Re: Application to Amend Order SWD-1641  
Mesquite SWD, Inc.  
Outer Banks SWD Well No. 1  
API No. 30-015-43868  
1990' FSL & 955' FEL, Unit I  
Section 13, T-20S, R-29E, NMPM,  
Eddy County, New Mexico

Mesquite SWD, Inc. ("Mesquite"), the successor operator of the Outer Banks SWD No. 1 respectfully requests that Order SWD-1641 be amended to authorize the use of 5 ½" tubing within the subject well from surface to packer setting depth, and to authorize minor changes in the casing program and open-hole interval hole size.

**Outer Banks SWD No. 1; Mesquite SWD Inc.; SWD-1641**

Mesquite SWD, Inc.  
Outer Banks SWD No. 1: Proposed Wellbore Schematic  
1990' FSL & 955' FEL (Unit I)  
Section 13, T-20S, R-29E, NMPM, Eddy County, NM

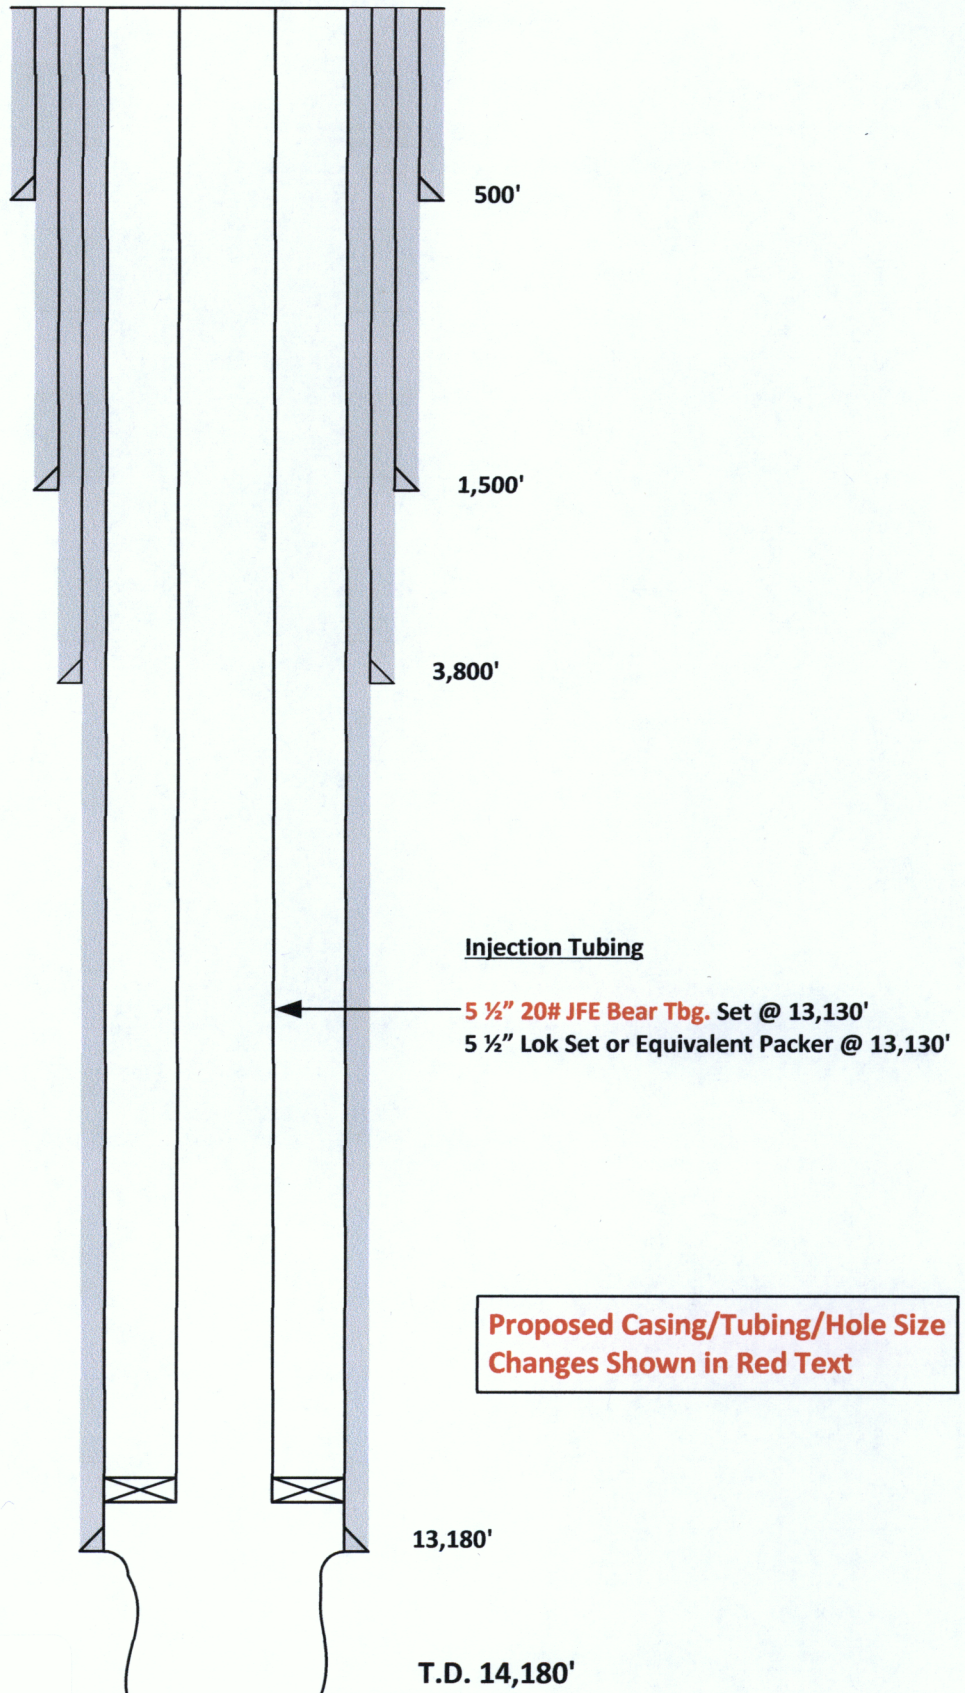
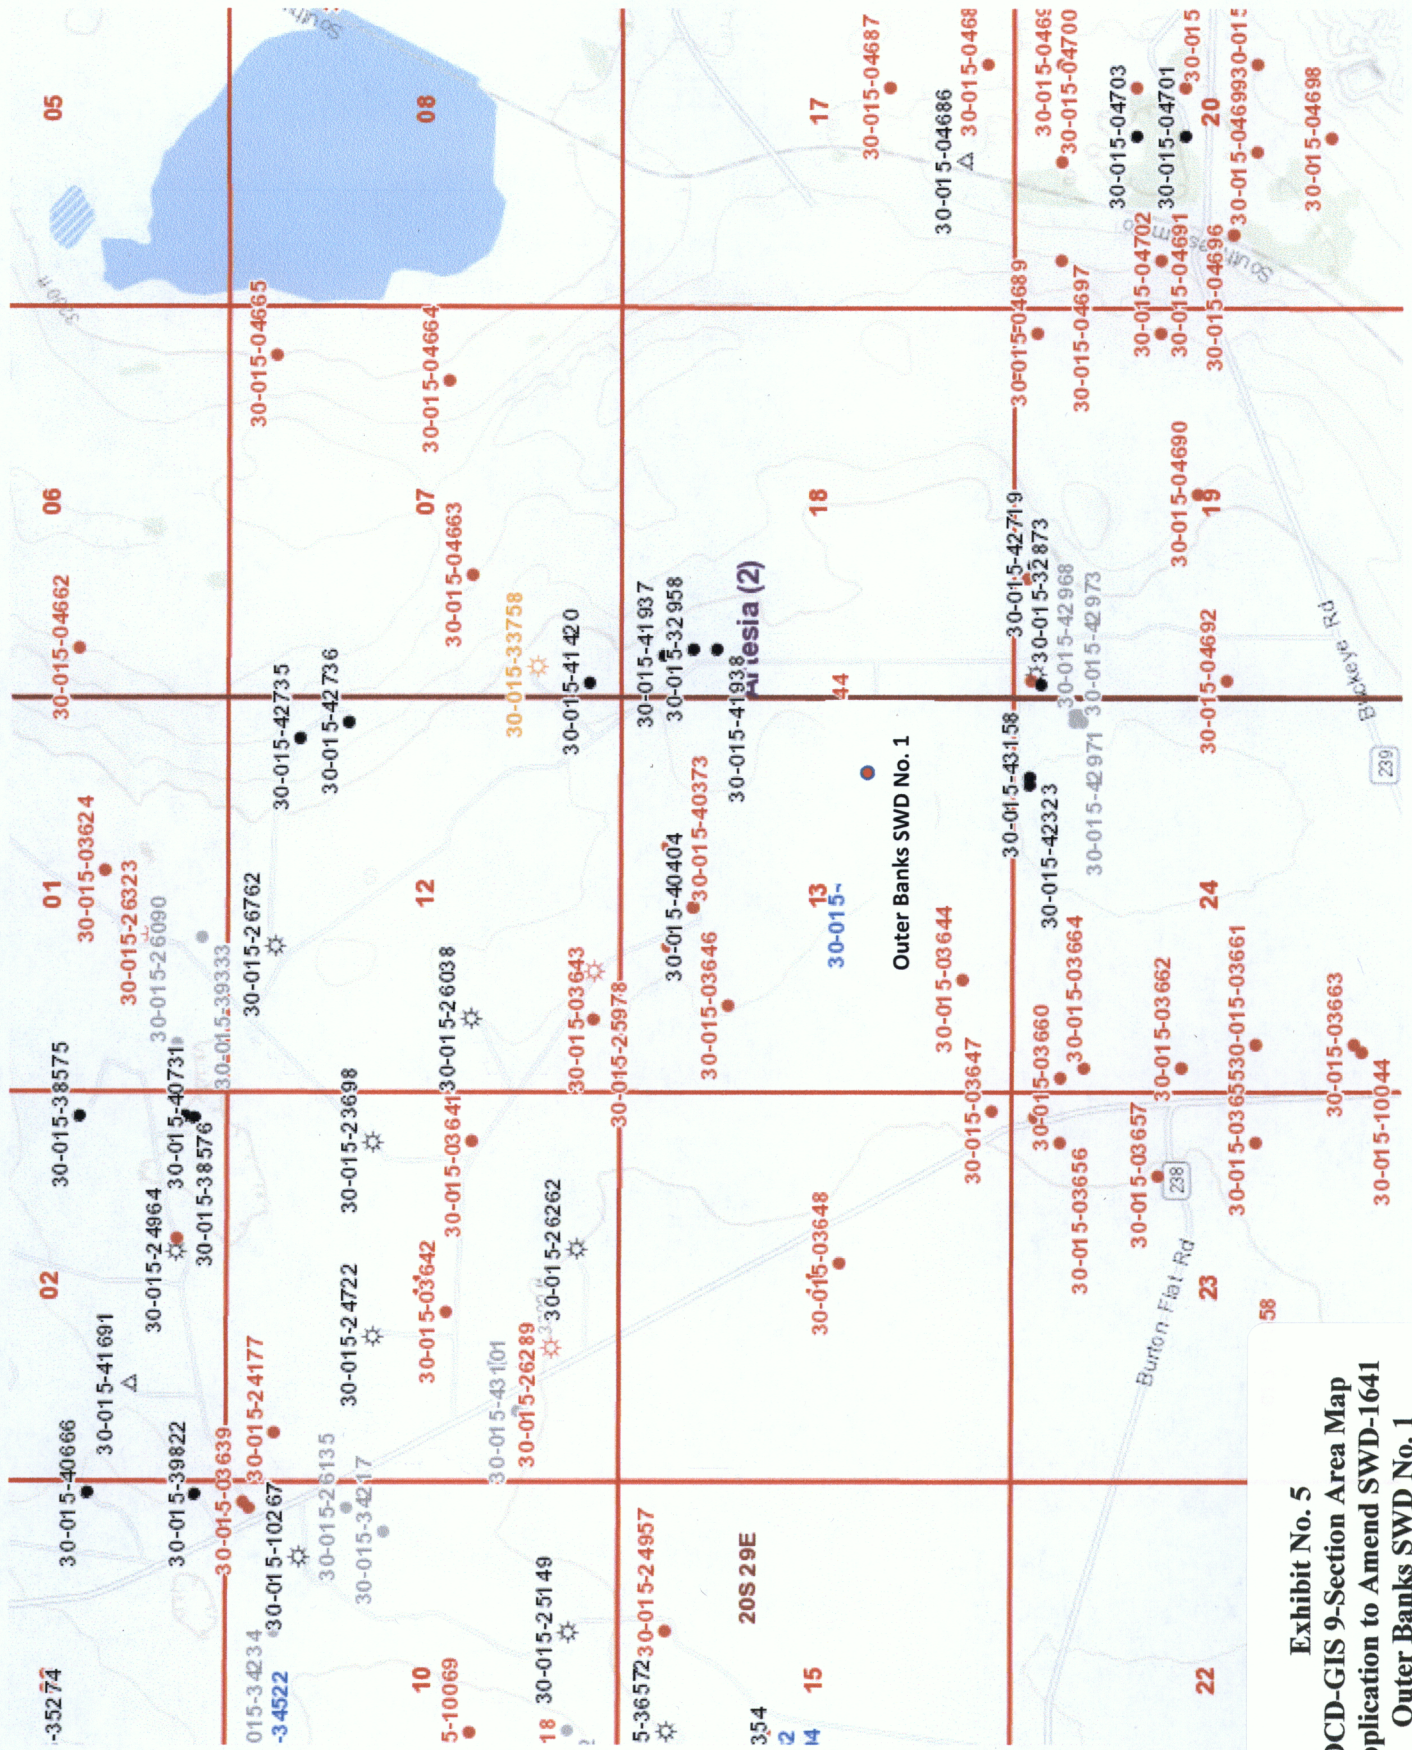
3. Attached is the wellbore schematic originally submitted with the C-108 application received by the Division on June 9, 2016 (Exhibit 3). Also attached is a wellbore schematic that shows the proposed wellbore configuration (Exhibit 4). In addition to the request to amend the tubing size, Mesquite also proposes to make the following changes to the casing program. These changes are highlighted on the attached wellbore schematic and on the BLM and OCD Sundry Notices attached:

<b><u>Original Casing</u></b>	<b><u>Proposed Casing</u></b>
Surface:	20" 106.5 J-55 LTC	20" 94# K-55 BTC
2 <sup>nd</sup> Int.	9 5/8" 53.5# L-80 LTC	9 5/8" 40" L-80 LTC
Production:	8 1/2" Hole; 7" 35# HCL80/ 29# P110 LTC	8 3/4" Hole; 7 5/8" 39# P-110 FJ Casing
Open Hole:	5 7/8" Hole 13,180'-14,180'	6 1/2" Hole 13,180'-14,180'

Hole Size: 26"  
Size: 20" 94# K-55 BTC  
Set @: 500'  
Sx. Cmt: 874  
TOC: Surface

Hole Size: 17.5"  
Size: 13.375" 68# J-55  
Set @: 1,500'  
Sx. Cmt: 1117  
TOC: Surface

Hole Size: 12.25"  
Size: 9.625 40# L-80 LTC  
Set @: 3,800'  
Sx. Cmt: 753  
TOC: Surface

Hole Size: 8.75"  
Size: 7.625" 39# P-110 FJ  
Set @: 13,180'  
Sx. Cmt: 1092 2-Stage  
Stage Tools: 9,500' & 5,500'  
TOC: Surface

Hole Size: 6 1/2"  
Interval: 13,180'-14,180'

## Wellbore Hydraulics Models predict a 33% increase in maximum injection rate between 5.5x4.5 tubing and 7x5.5 tubing.

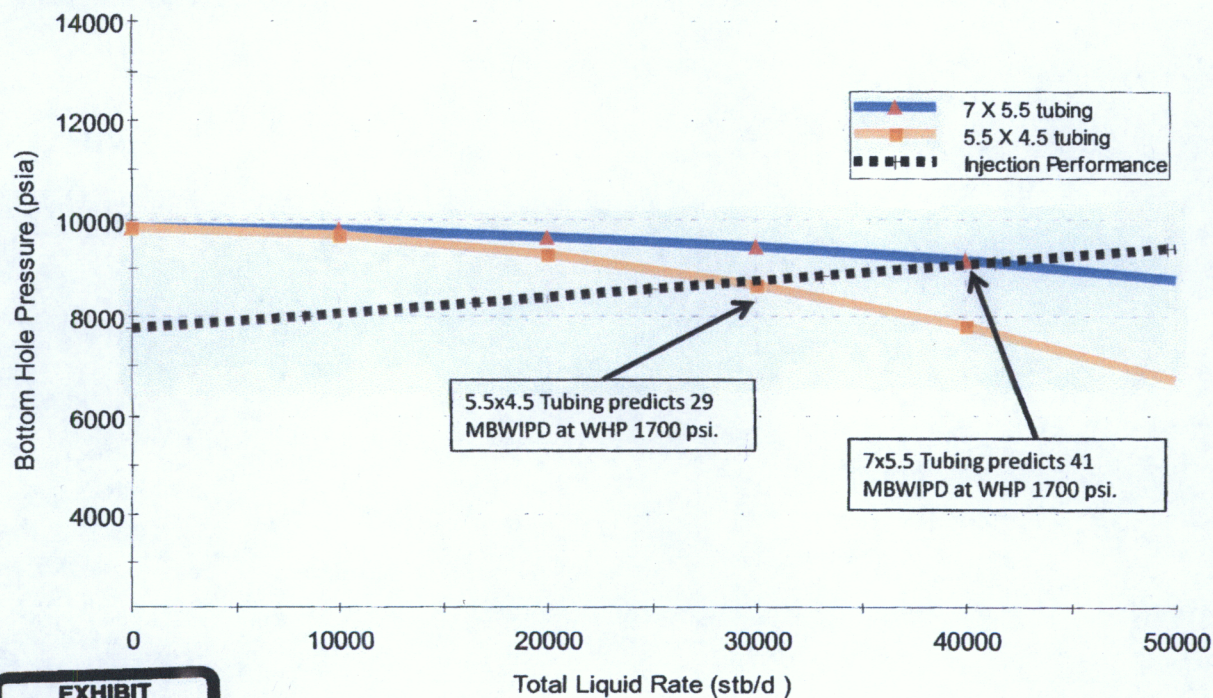
8. Attached is a document presented in Case No. 16308 which demonstrates that increasing the tubing size in a Devonian well in this area will result in an increase in injection rate from 29 MBWPD to 41 MBWPD (Exhibit 8). The resulting increase in injection rate will mean that less produced water disposal wells will be necessary to accommodate the ever-increasing demand for disposal.
